**DATE:** April 10, 2024

**TO:** Visual Arts Committee

**SUBJECT:** **Discussion on City Council Direction Related to Public Art at Evelyn Park, Project 21-60**

Attachment: 1. Revised Concept for "Butterfly Reflect" by Looking Up Arts

**Figure 1: Looking Up Arts Original Concept—“Butterfly Reflect”**

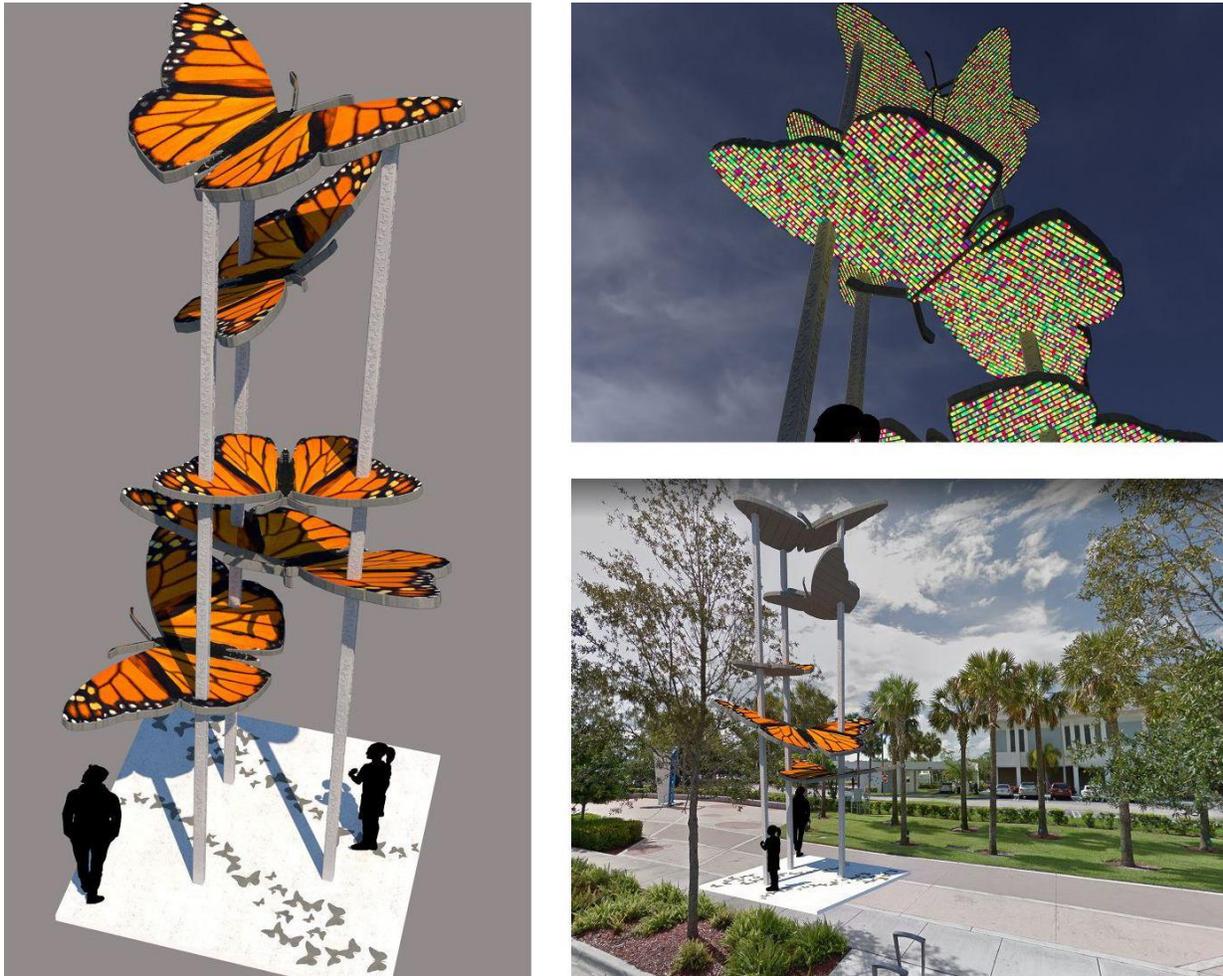
The original concept (Figure 1) included an LED panel on the bottom side of each butterfly that mimicked a visual of monarch butterflies migrating or flying.

At the City Council’s Regular Meeting on [February 27, 2024](#), the City Council discussed the art recommendation and referred the public art for Evelyn Park back to the Committee to address the LED lighting and the interaction with dark skies and the park-goer experience related to the underside of the butterflies.

1. What should the park-goer experience look and feel like at ground-level, underneath the butterflies? What elements of the piece can be improved at ground-level?

2. Should lighting be incorporated into the piece? What does the piece look like with reduced lighting or no lighting?

**Figure 2: Looking Up Arts Revised Concept**

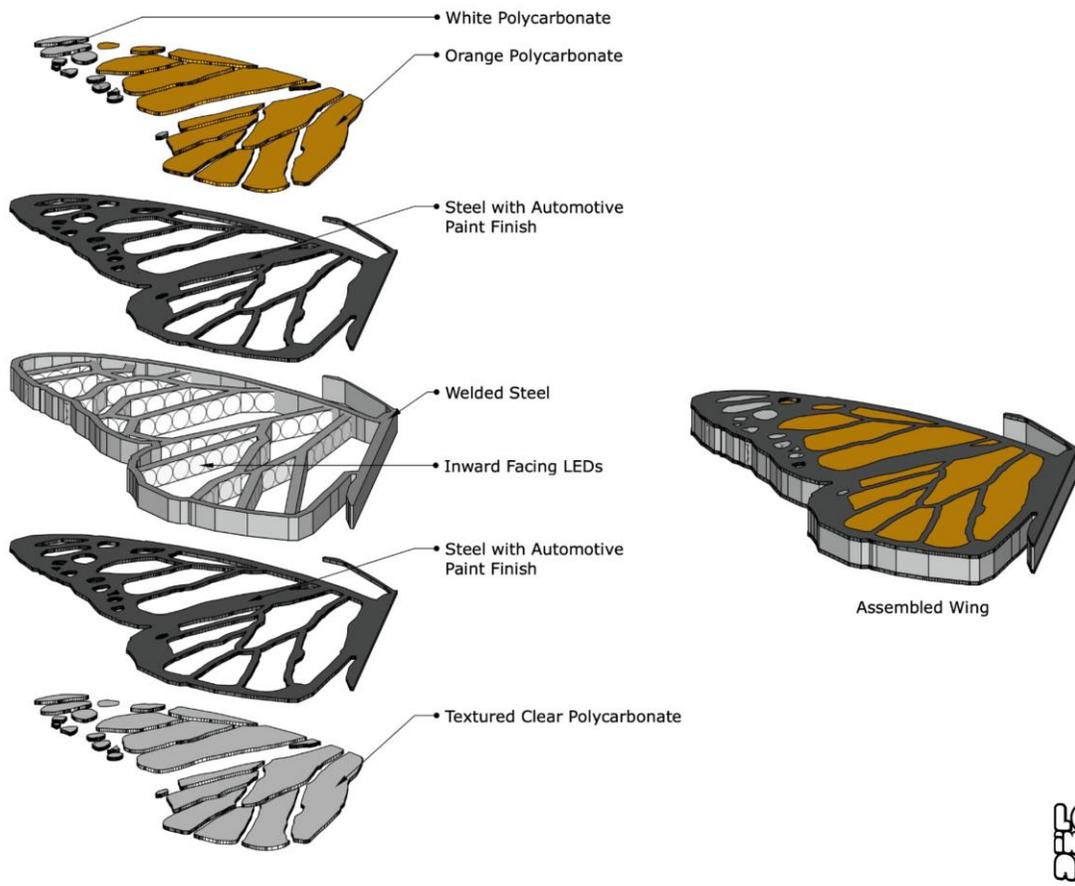
At the VAC meeting on March 13, 2024, the Looking Up Arts artist team shared a revised sculpture concept based upon Council's feedback. The revised concept described in Attachment 1 (shown in Figure 2) allows for more natural light to come through the top of the butterflies as well as incorporating fewer LED lights within the inside of the sculpture to light within. The lights would be able to turn off at a specified time.

The VAC directed staff to work with Looking Up Arts to address lighting that is consistent with other lighting standards in Mountain View parks.

Looking Up Arts can adjust the lighting remotely to align with the operational hours, as described above, and to align with seasonal lighting changes. Adjustments can be made at the request of the City to the illumination or light level and color as well as the duration or time of day that lights are on.

Figure 3: Evelyn Park

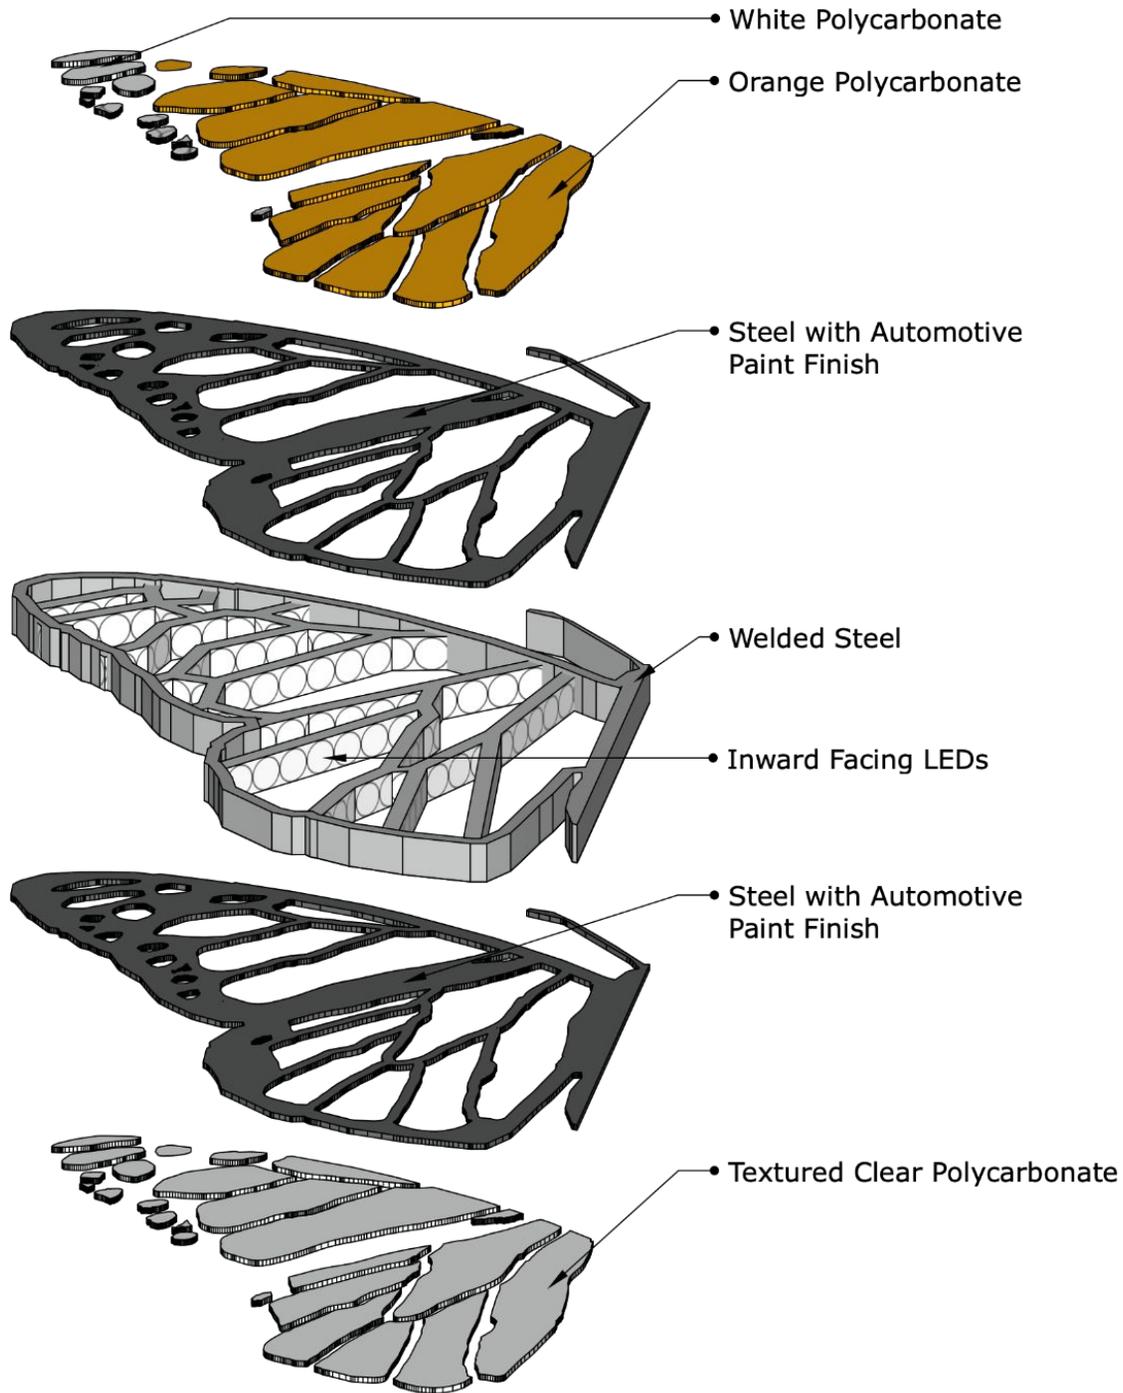
As it relates to the ground-level experience, Public Works project staff indicated that the art would need to be placed on the pavers within the plaza at Evelyn Park (Location No. 1 in Figure 3), and to maintain consistency throughout the plaza, the pavers will need to be placed around the base of the art rather than a concrete pad as proposed by the artist team. Looking Up Arts will work with staff to determine feasibility to customize the pavers with butterfly outlines underneath the art to enhance the ground-level user experience and stay within the project budget and timeline.
